**GENOA CHARTER TOWNSHIP
PLANNING COMMISSION PUBLIC HEARING
APRIL 8, 2024
MONDAY
6:30 P.M.
AGENDA**

Attention:	Amy Ruthig, Planning Director
Subject:	Pinnacle Wealth Management – Special Land Use and Site Plan Review #3
Location:	5311 Brighton Road – north side of Brighton Road, between Chilson and Bauer Roads
Zoning:	MUPUD Mixed Use Planned Unit Development

At the Township’s request, we have reviewed the revised submittal from Pinnacle Wealth Management to convert the use of and expand the existing building, and to hold events with music on an outdoor patio for the property at 5311 Brighton Road (cover sheet dated 3/12/24).

SHEET NO. 5
BOSS ENGINEERING

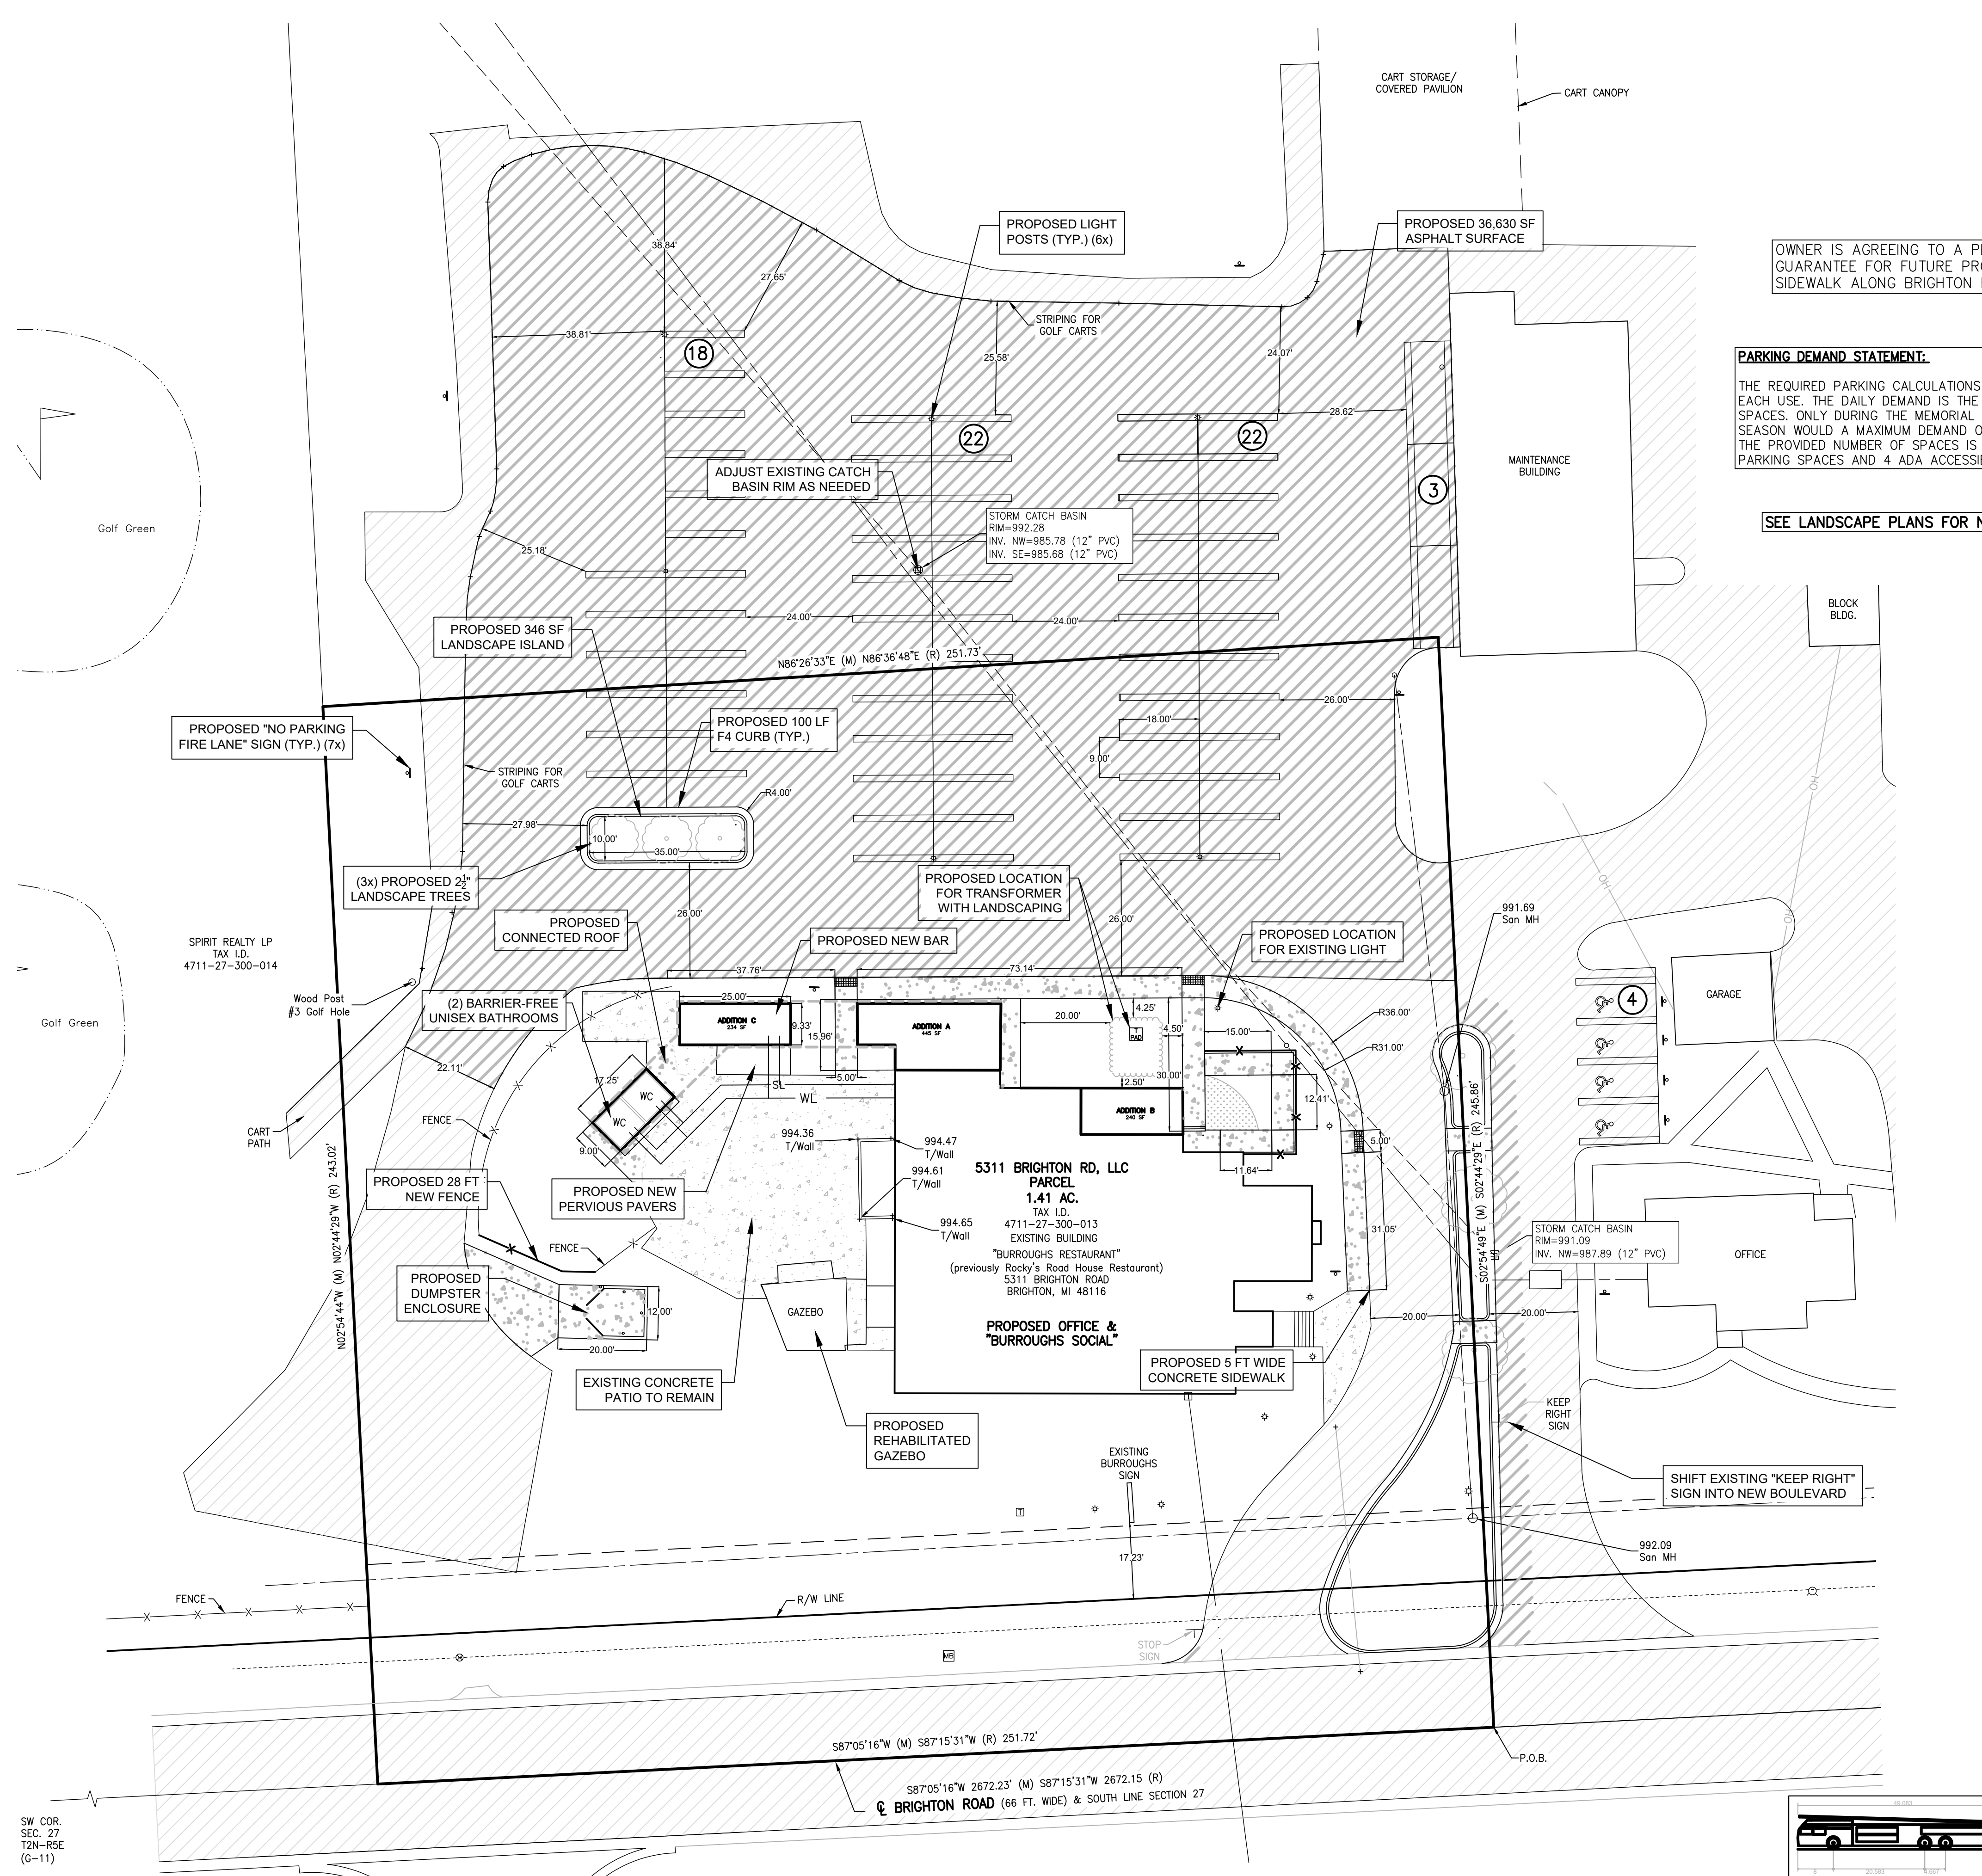
- a. Building materials and design are subject to review and approval by the Planning Commission.
- b. The site plan and floor plan drawings note different square footage for the building additions and should be corrected for consistency.

- e. We suggest the applicant provide their shared parking agreement with the adjacent property.
- f. The parking lot includes parallel spaces, which we typically advise against for circulation purposes (though they comply with Ordinance standards).

Lastly, the site plan and floor plan drawings identify different sizes for the proposed additions. The plans should be corrected for consistency.

In total, the shared parking lot provides 69 spaces, while the office and event uses are expected to occur at different peak times. The Township does not have a shared parking agreement on file. As such, we request the applicant provide this information.

The plan provides 4 barrier-free parking spaces, which meets Ordinance requirements; however, we suggest these spaces are located near the building on the adjacent property. As such, we suggest the applicant relocate at least some of the barrier-free parking for better access to/from their building.

1 LANDSCAPE PLAN

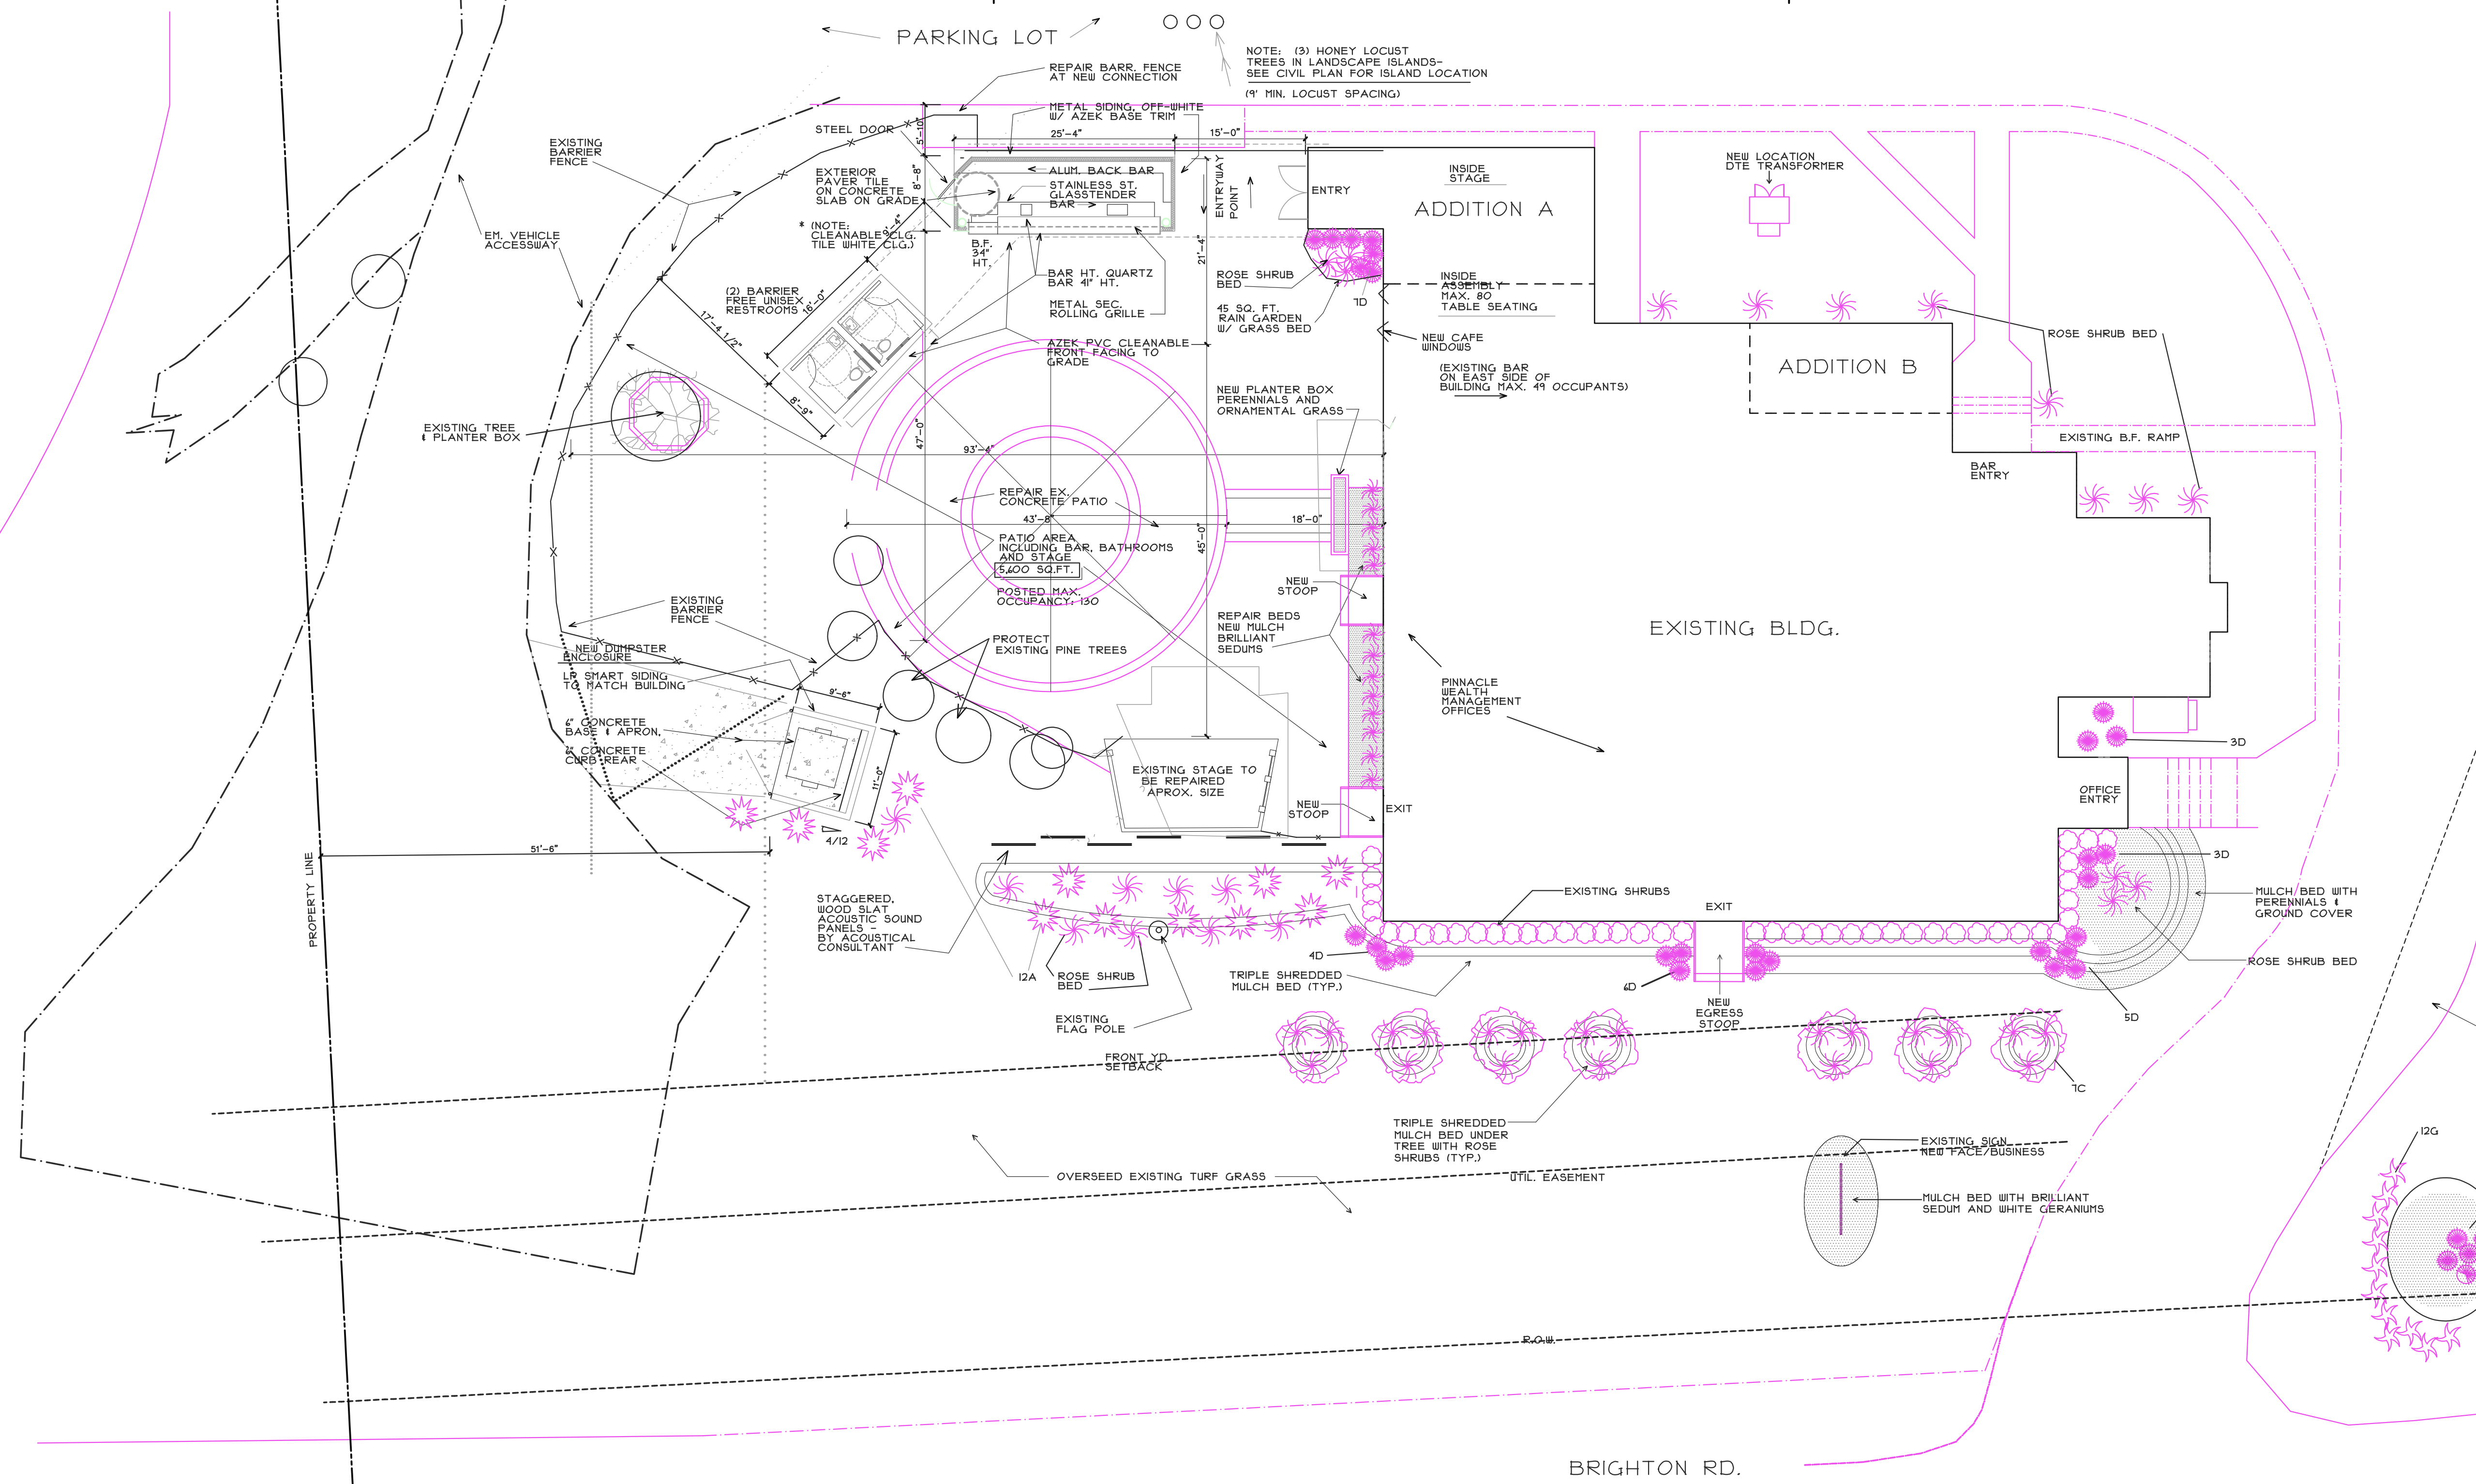
- i. Ornamental wall mounted fixtures noted in the Impact Assessment must be added to the lighting plan.
- j. There are inconsistencies between the landscape plan and plant list that need to be corrected.

- k. We suggest the applicant provide additional landscaping around the waste receptacle/enclosure.

- 7. Landscaping.** The landscape plan includes the required greenbelt trees, provides for some parking lot landscaping (where there currently is none), and maintains/supplements landscaping around the building and outdoor patio area.
